STAFF REPORT: DECEMBER 11, 2024 MEETING

APPLICATION NUMBER: HDC2024-00570

ADDRESS: 751 CHICAGO BOULEVARD

SCOPE: REPLACE FRONT DOOR AND TRANSOM

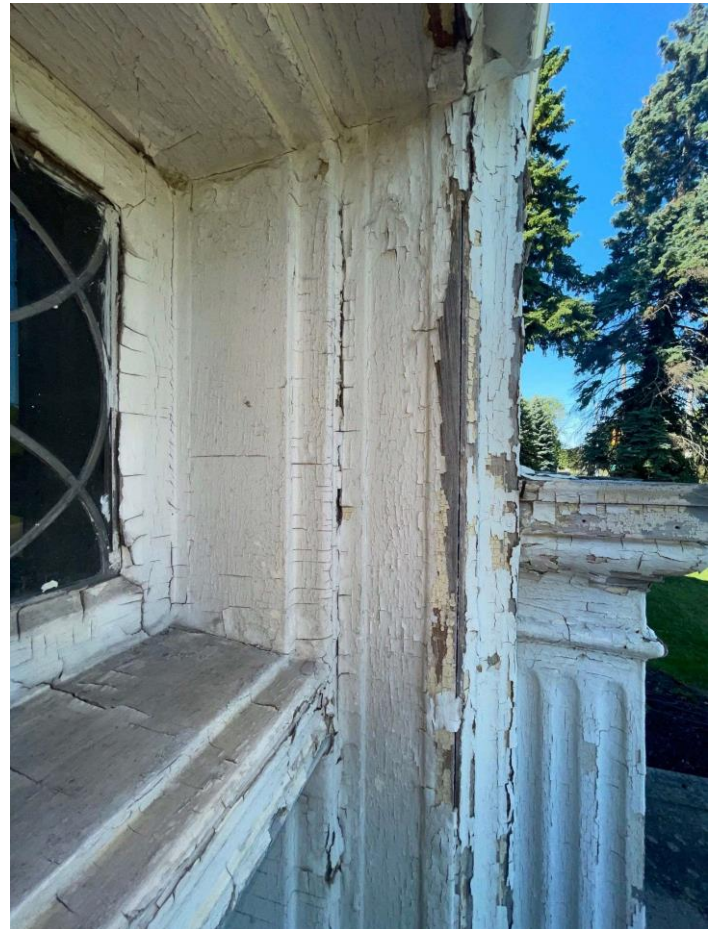
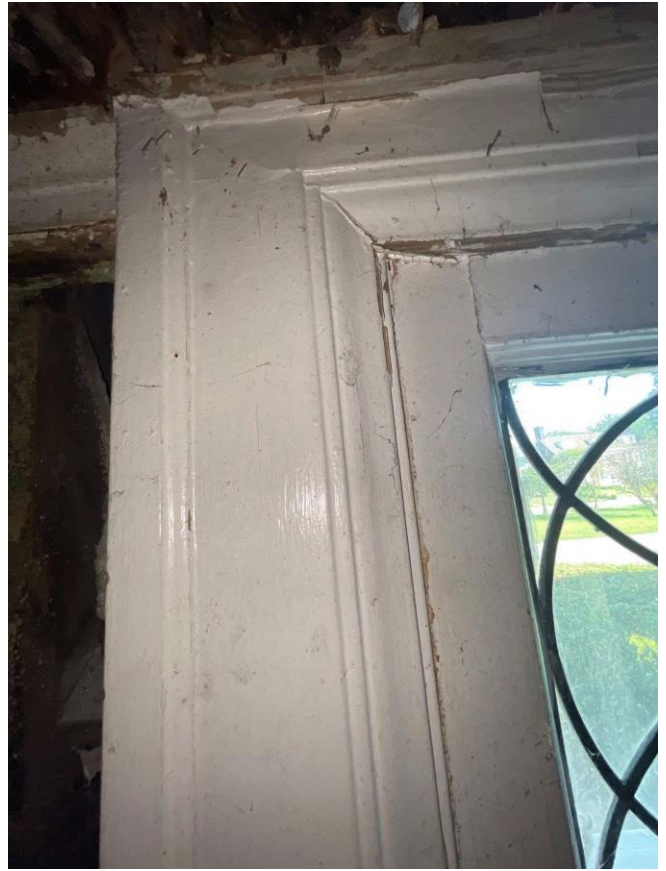
- It is staff's opinion that the existing French doors and transom are historic-age and are distinctive character-defining features within the larger highly detailed entry portico.
- The applicant is not aware if the owner obtained a repair estimate for the doors and window. Staff made multiple requests to the applicant that they submit details on why it is stated that the current door is beyond repair.

Applicant photographs. The entire entry surround requires repair and repainting, and that missing elements be fabricated and installed. For this application's scope of work, the transom window (glass and lead cames) and French doors are intact and repairable; new glass panels can be ordered for the doors.

Applicant photographs. The interior framing understandably exhibits less weathering than the exterior, and only requires spot repairs and repainting, as well as the new glass for the doors.

- The French doors and leaded glass transom are character-defining features, and the applicant has not provided information to support that they are beyond repair. Therefore, replacement products should not be considered at this time. Additionally, when windows and doors are beyond repair, the Standards require that the new components must match the old in design, dimension, and operation.

- The historic leaded glass transom window and French doors are distinctive, character-defining features of the house, and their removal and replacement would substantially alter the appearance of the dwelling.
- The applicant hasn't substantiated that the doors and window are beyond repair, therefore replacement of these components should not be considered at this time.
- Additionally, if replacement components are considered, Standard Six requires the new doors and window match the old in design, materiality, texture, and other visual qualities.

Staff therefore recommends that the Commission issue a Denial for the work as proposed, as it does not meet the Secretary of the Interior's Standards for Rehabilitation, specifically Standards 2, 5, and 6:
